Work Order ID 85390

Item Name: Crosstube Turning Detail

DART AEROSPACE LTD	Work Order: 85391
Description: Crosstube Assembly (412 High Aft)	Part Number: D412-664-243
Inspection Dwg: D412-664-243 Rev: E	Page 1 of 1

DRAWING NO. D412-664-243	TITLE CROSSTUBE ASSEMBLY (412 HI AFT)	REV. E	DART AEROSPACE LTD ENGINEERING ORDER		D.E.O. NO. D412-664-243-E-1	SHEET NO. SHEET 1 OF 2	SCALE NTS
DRAWN	CHECKED	MFG. APPR.	APPROVED	DE APPR.			
DATE 11.03.31	DATE 11/03/31	DATE 11.03.31	DATE 11/03/31	DATE 11-03-31

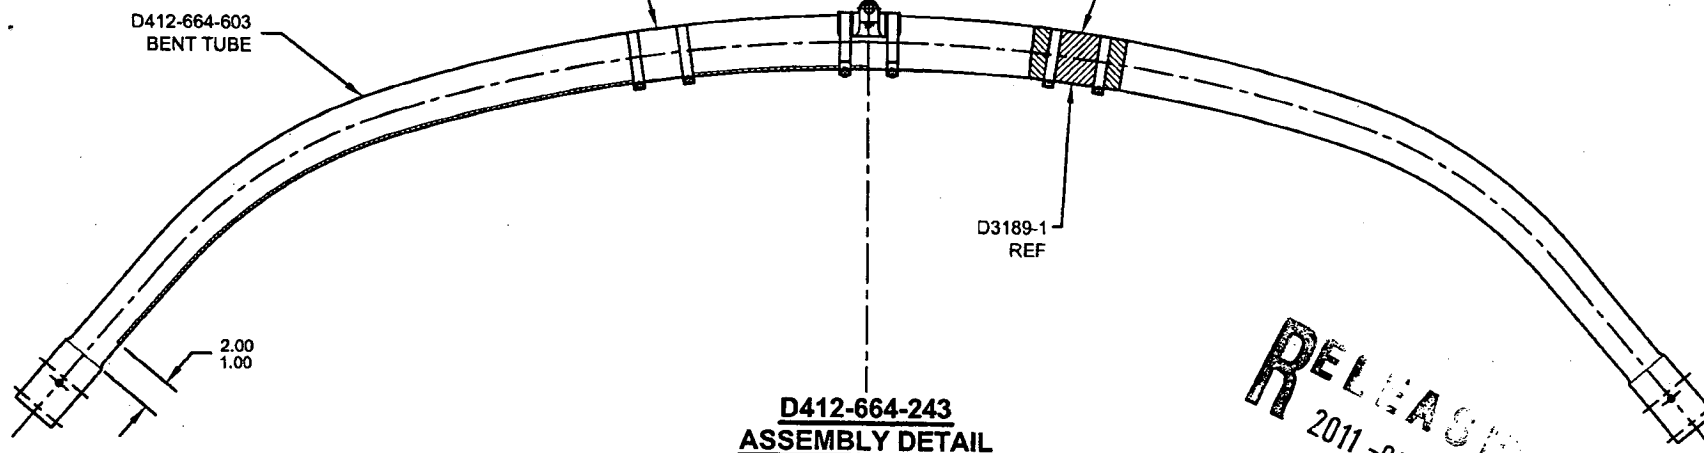
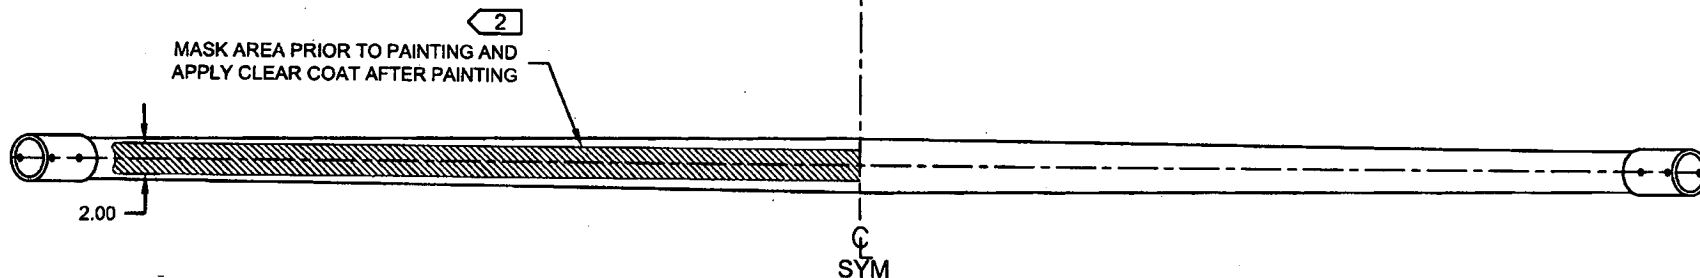
PURPOSE:

REMOVED ABRASION STRIP IN FAVOR OF A THIN LAYER OF PROSEAL 890.

IS:

D3189-1 CHAFING SHIELD (1, INSTALLED OVER PROSEAL 890)
MS21920-28 CLAMP, 2X
2 PL

WAS:

D2856-600-1009 ABRASION STRIP
D3189-1 CHAFING SHIELD (1, INSTALLED OVER ABRASION STRIP)
MS21920-28 CLAMP, 2X
2 PL
